**OCONEE**

**February 2002  
WRITTEN EXAM**

**UTILITY  
COMMENTS**  
**WITH SUPPORTING  
DOCUMENTATION**

**QUESTIONS REPORT**  
for 2002-301 COMBINED UTILITY COMMENTS R1

Enclosure 13.12  
Unit 1 Cycle 20  
Loop  $\Delta T$  Vs. Reactor Power

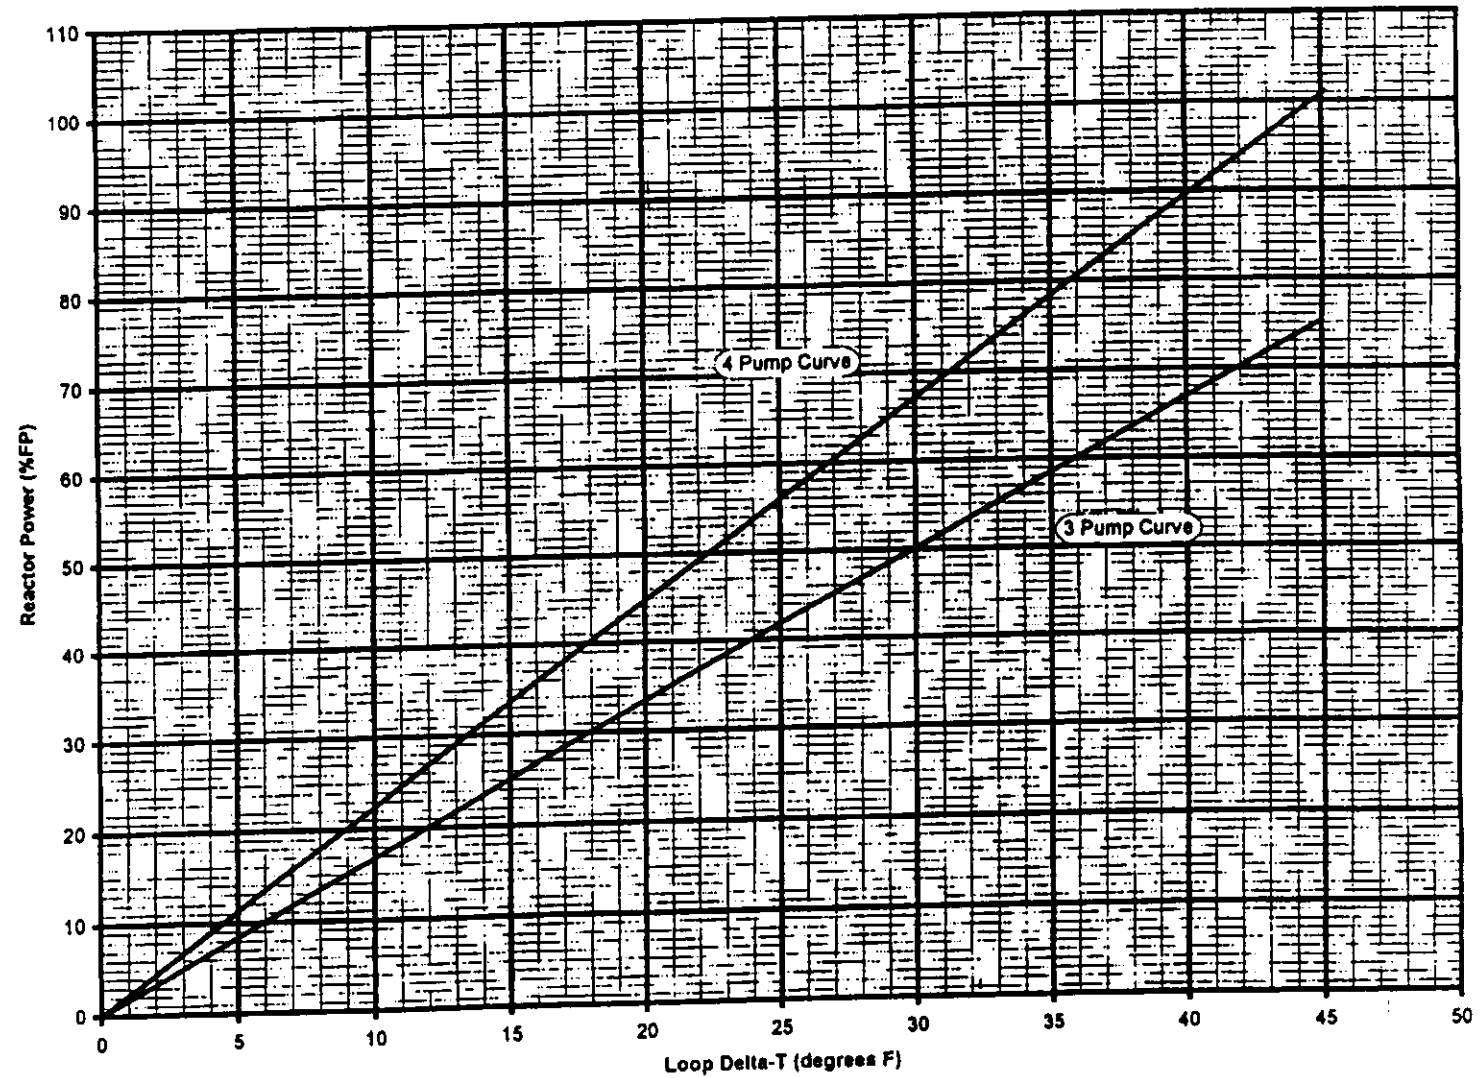
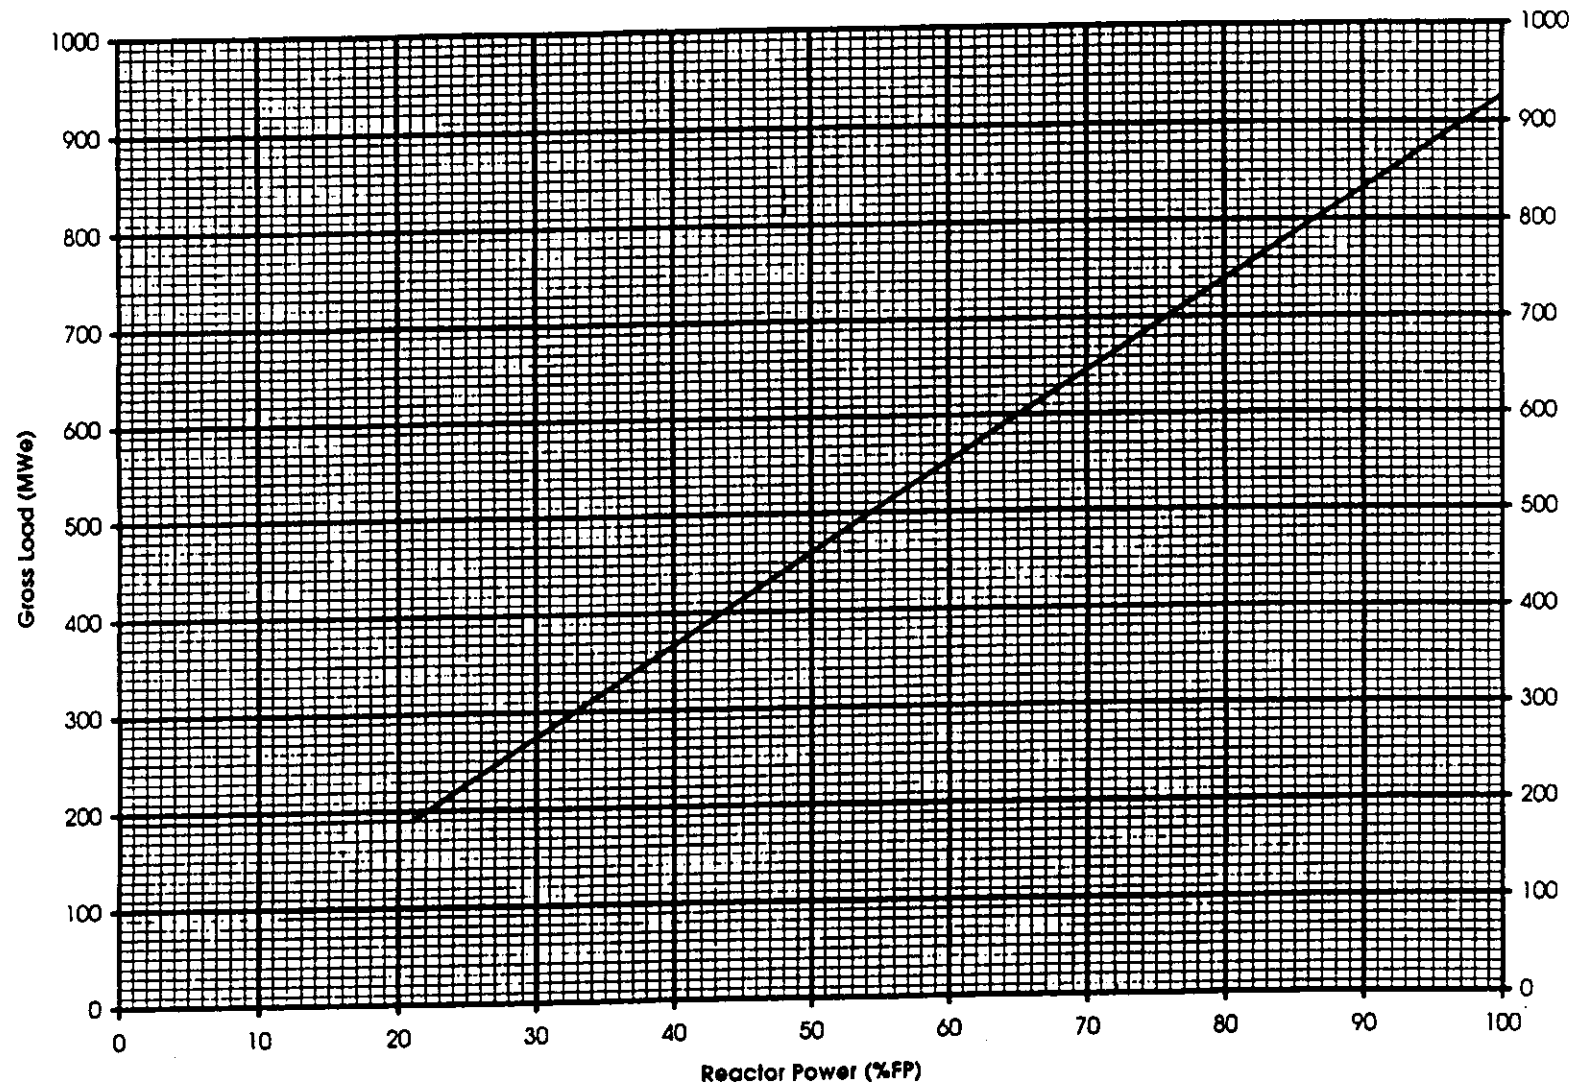
Question originally written using 2544 as MWth. Changed to 2568 per ONS 100% thermal rating.

ONS operators will utilize PT/600/001, Periodic Instrument Surveillance to verify reactor power.

Added attachments encl.13.12, Loop deltaT vs. Rx Power and encl.13.13, Gross Load vs. Rx Power.  
Added Mwe value of 320 to stem.
